Re: Amendment to Existing DEP File #300-1035 – Rev 1  
70 Westwood Drive, Sturbridge, MA 01566

Proposed Changes to original Jalbert Plot Plan Rev 4 Dated 10<sup>th</sup> Sept, 2019  
 approved for DEP File #300-1035

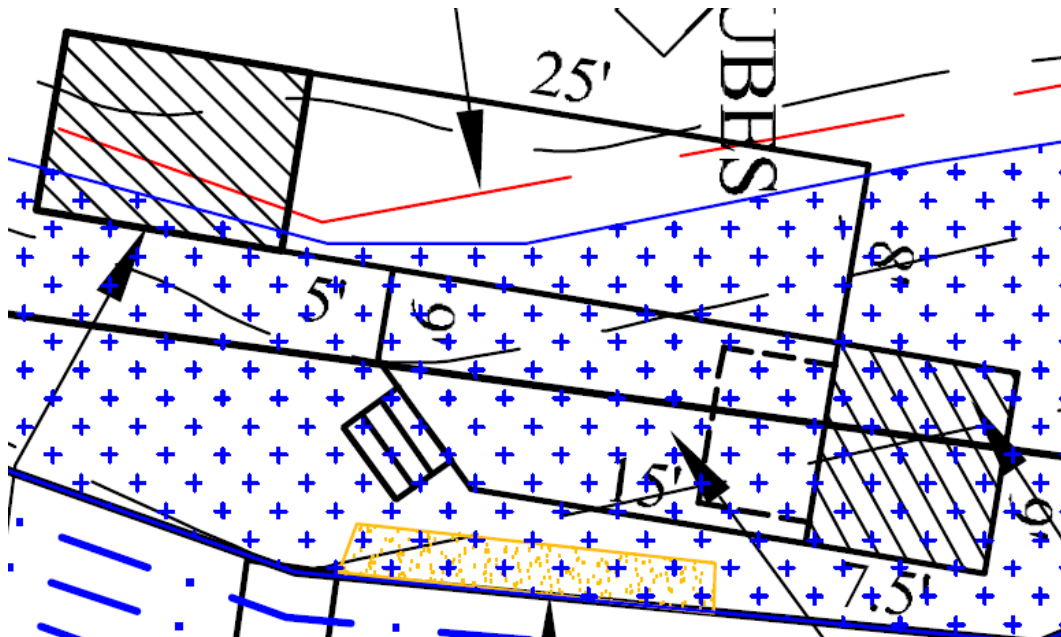
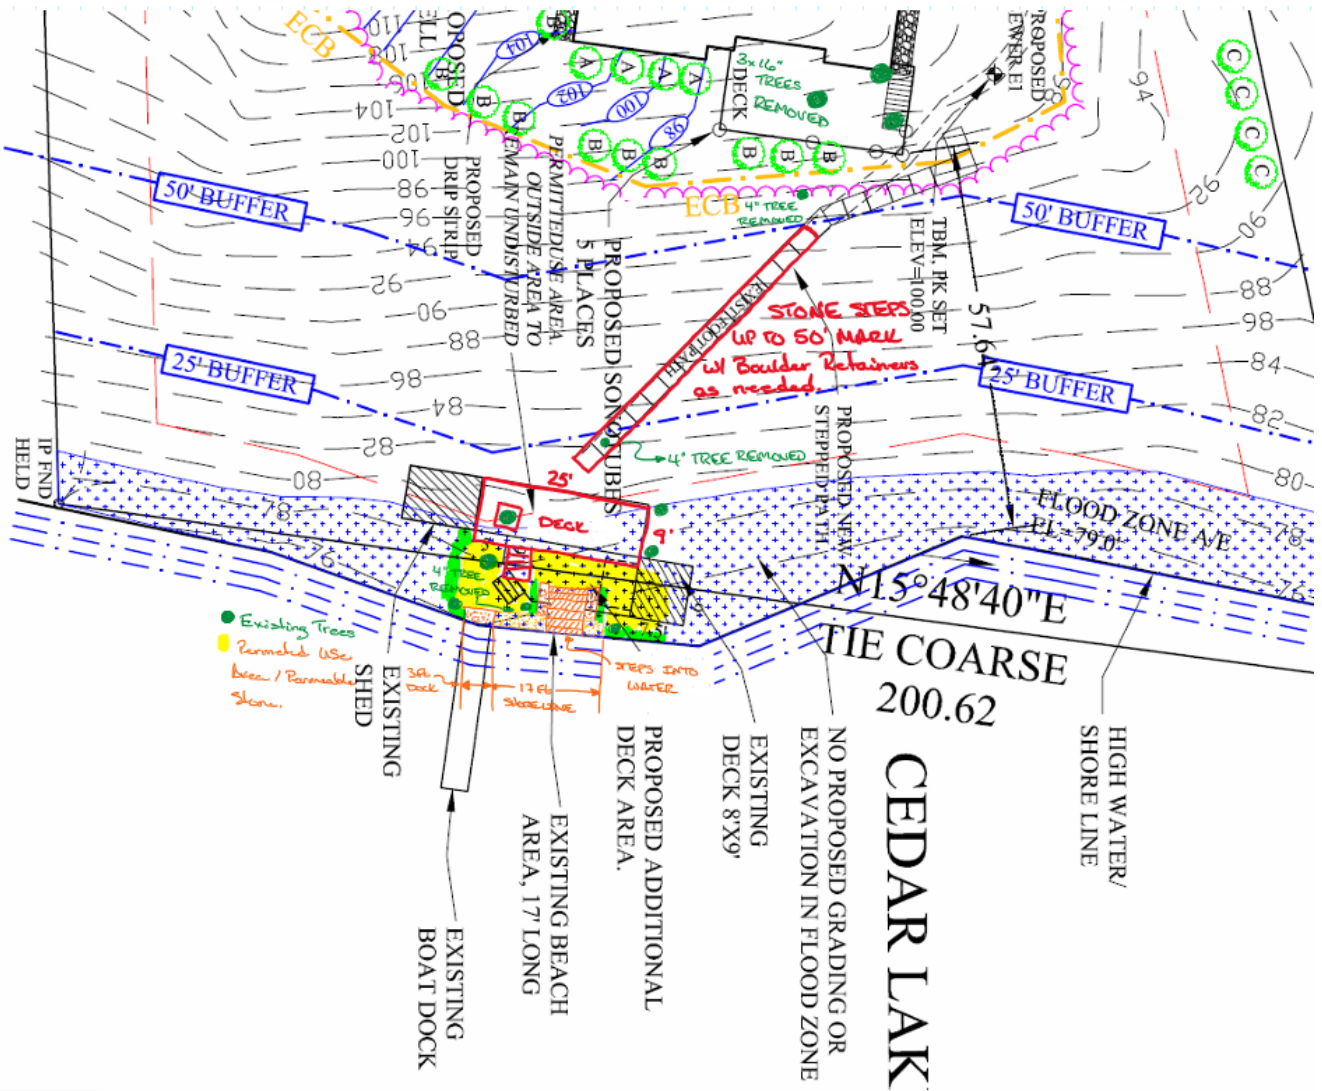
- Placement of approx. 22 stone steps from the 50ft buffer mark to the existing permitted use area in lieu of the 8x8 timbers/crushed stone currently outlined, with the use of boulders as necessary as to maintain hill integrity.

- Placement of a 25ft x 9ft wood/composite deck in the current permitted use area.
- Removal of the current proposed 29ft x 9ft deck area and replacing it with a 200 sq/ft water permeable stone patio with spaced joints.

- Addition 20 linear foot by ~4ft tall shoreline wall consisting of natural boulders with 6ft stone steps into the water.
- Removal of three 4in diameter trees within 50ft buffer zone to allow equipment access to shoreline.

- Removal of three 16in diameter trees within previously approved area to be cleared for phase II to allow equipment access to shoreline.
- Replanting of 6 sapling trees (oak or walnut) following completion of phase I in 50ft buffer zone.
